PLANNING DEPARTMENT STAFF ANALYSIS DEVELOPMENT MASTER PLAN

CASE NO. 2022-0017

REQUEST Development Master Plan for Glacier City Center

LOCATION Tract E3, Girdwood Elementary School Subdivision

OVERALL LANDSCAPE PLAN

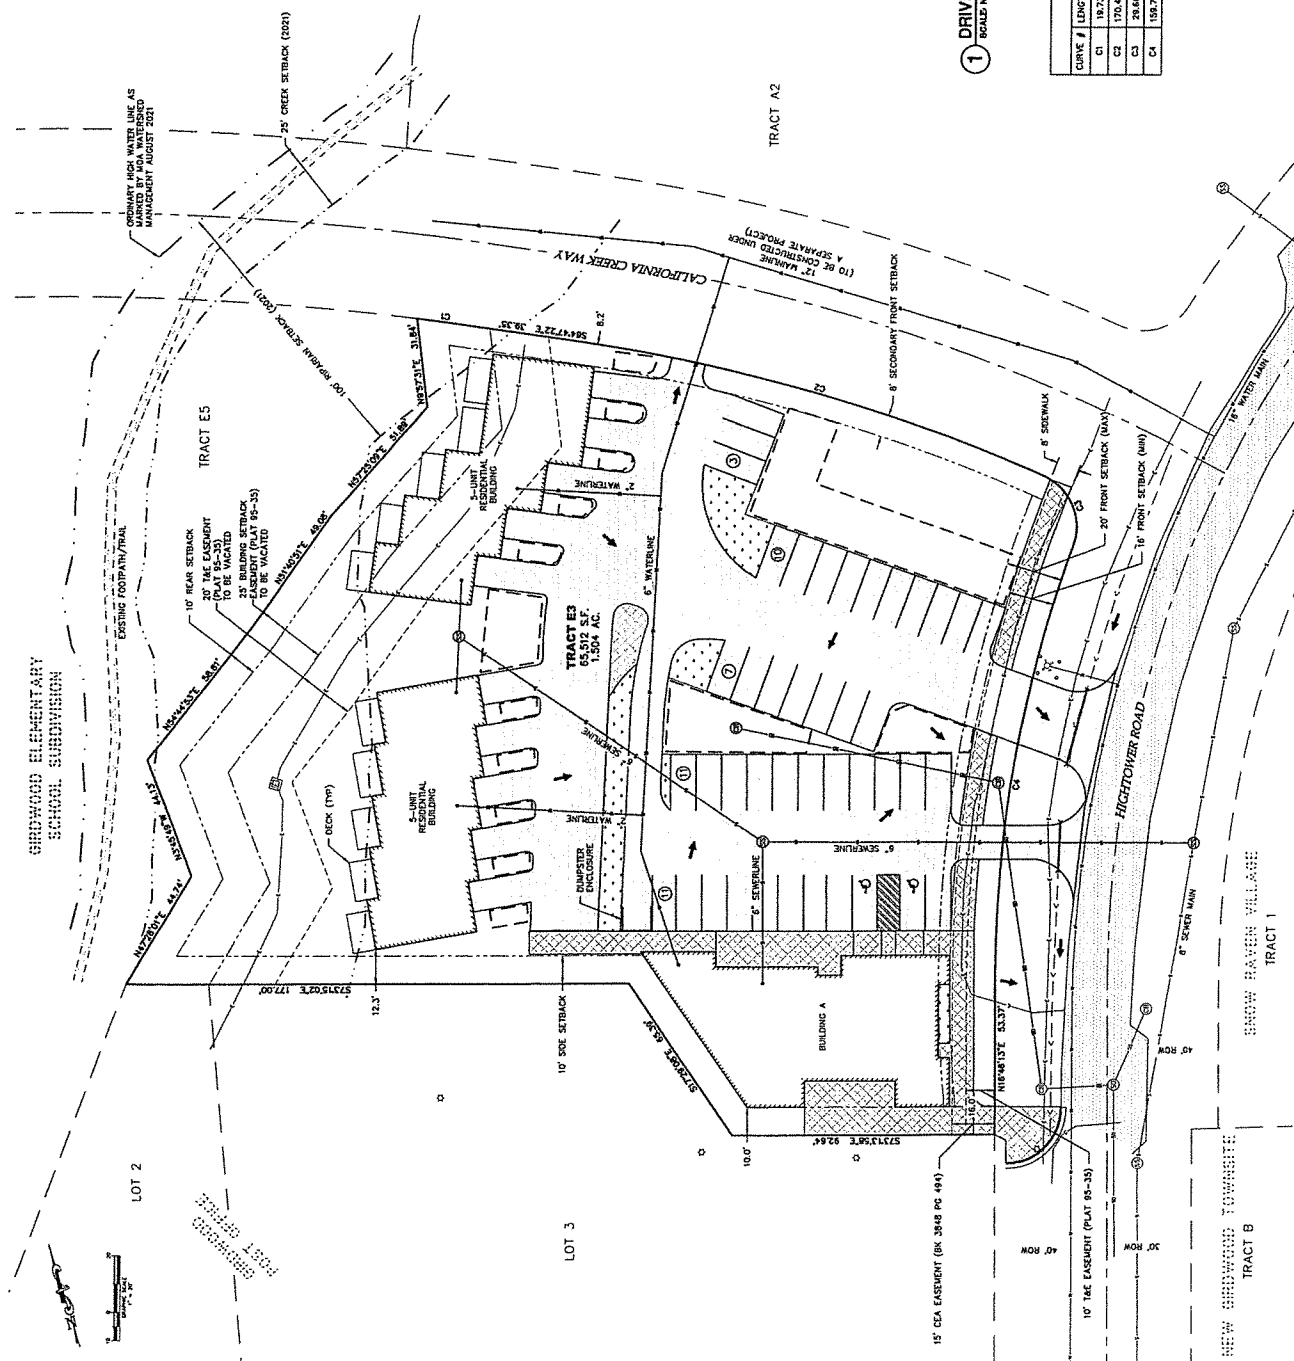
- Provide analysis to determine if 14-foot poles are sufficient for exterior parking space lighting for commercial portion of the development.
- Sheet L1.0 shows required landscaping is located in existing municipal right-of-way, which is not allowed by municipal code. Move landscaping to property.

Review of Sheet L1.0 appears to show some of the proposed required landscaping to be located within the existing Municipal Right of Way. Revise site plan to remove any required landscaping within Municipal ROW.

4. Remove landscaping shown within the right-of-way.
5. Reduce the number of driveway connections to Hightower Road from two driveways to one driveway.
6. Vacate the 25-foot building setback easement and vacate or realign the 20-foot telecommunications easement and 8-foot electrical easement on Plat 95-35 where in conflict with proposed structures near the western property line through a separate platting action.

A0.5
SITE PLAN

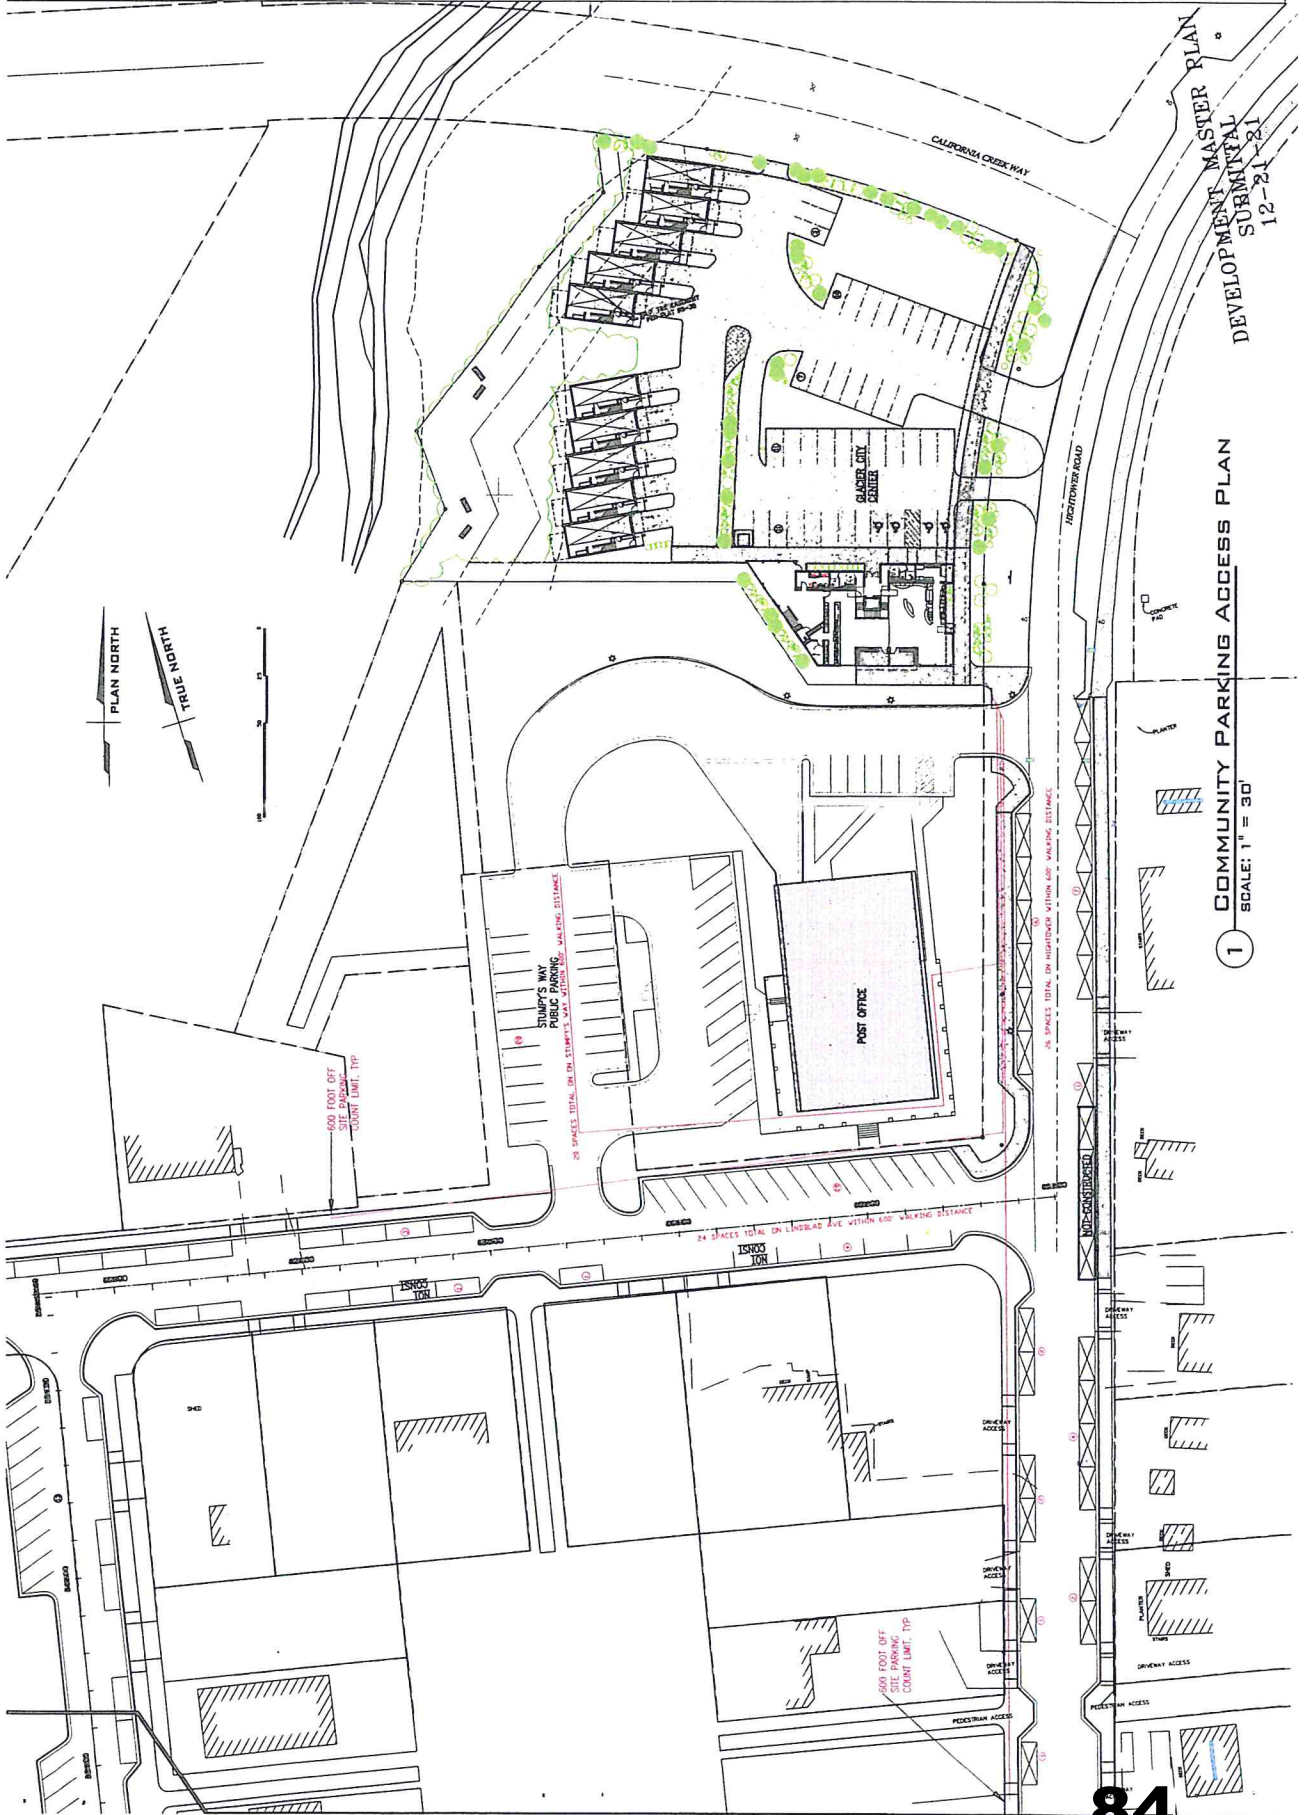
The development plan indicates that 96 parking spaces are required per Table 21.07-4. Sheet A0.5 shows that there are sufficient community parking spaces available to be eligible for a parking reduction for the site. Traffic Engineering is requesting that a condition of approval for this proposed development plan provide a recorded parking agreement with the Municipality.

- f. Record a parking agreement.
8. Resolve with Private Development the following:
- a. Submit comprehensive grading and drainage plan and storm water management report.
